**E5061B-02**

**S E R V I C E N O T E**

"E5061B Network Analyzer, 5 Hz to 3GHz"

**A screw for heat sink of CPU board might become loosened.**

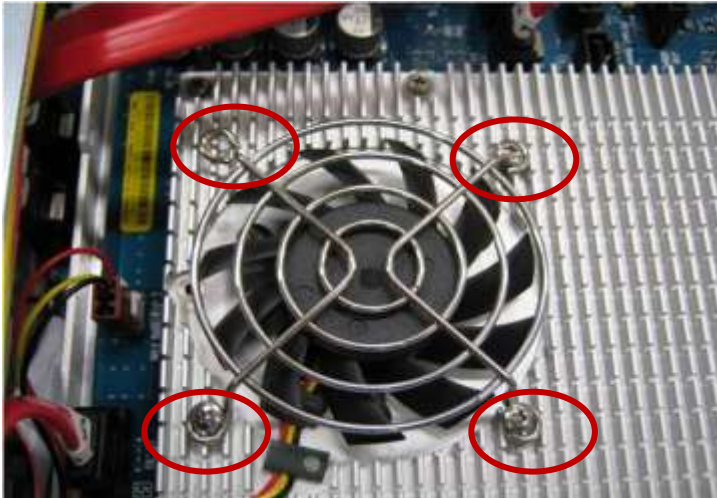
A screw for heat sink of CPU board might be loosened or removed, due to wrong screw position.

Right Position

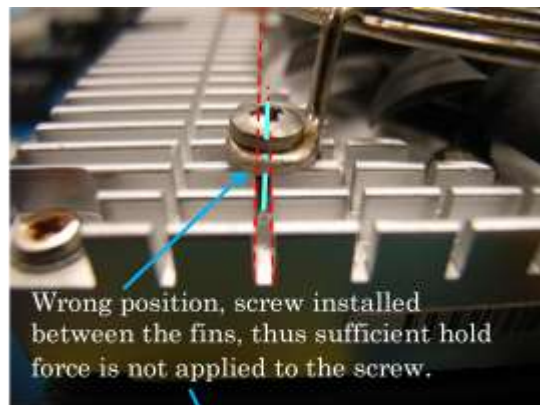
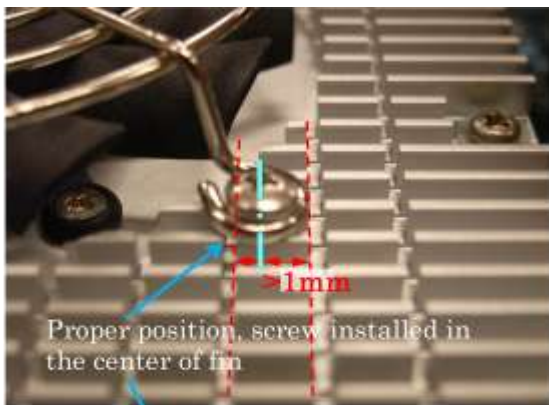
Step-2. Check the positions of all the four screws.

Wrong Position

In case of Wrong position of the screw, remove the wrong position screw and tighten the screw with Right position.
